Product change notification (PCN)

Title / short description	TC ROUTER 3002T-4G GL, approval for Japan, removal of packing slip
Affected article category	Industrial communication technology
Change category	Approval, Material
Change number	CDN260021-00
Reason for PCN/PDN Revision

CDN260021

TC ROUTER 3002T-4G GL – Laser marking

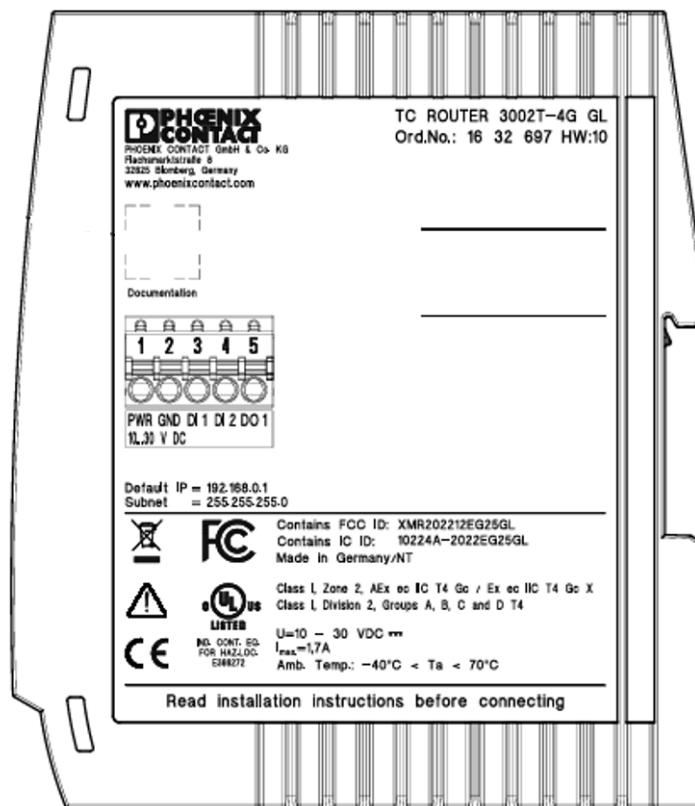
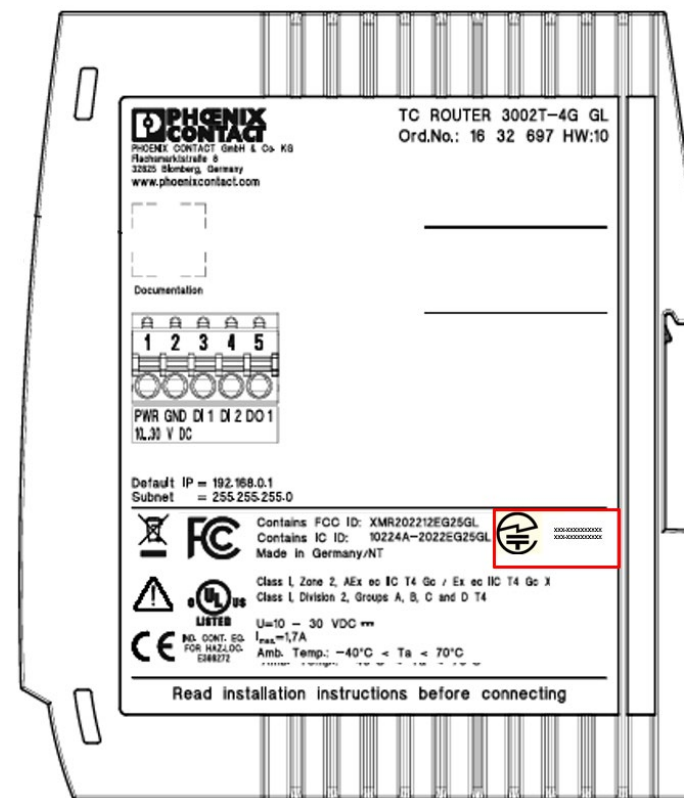
Additional information: Approval for Japan
